DSO9104A-04

S E R V I C E N O T ESupersedes:
None**DSO9104A Oscilloscope: 1 GHz, 4 analog channels**

Serial Numbers: MY0000001-MY52250100, SG00000001-SG52250100

Figure #1.

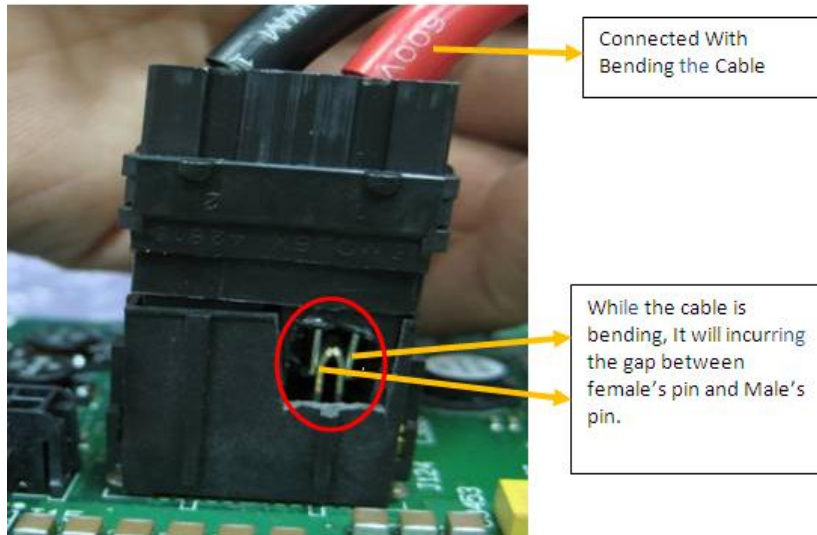
Many customers are experiencing Random Shutdowns. This make them want to have Service Note - 02A completed. The problem is with service note -02A, this isn't the only possible cause for the symptom consequently not resolving their problems. This issue has been determined to be a connection problem with the J124 connector on the acquisition assembly and the 12 volt power cable. See figure #1.

Replace the 12 Volt Bulk power cable to the longer version 54904-61631 eliminating the connector tilt increasing the surface tension. See Figure #2. Clean and inspect the connection J124 on the acquisition board. If the J124 is pitted then replace the acquisition board. Use contact cleaner or alcohol.
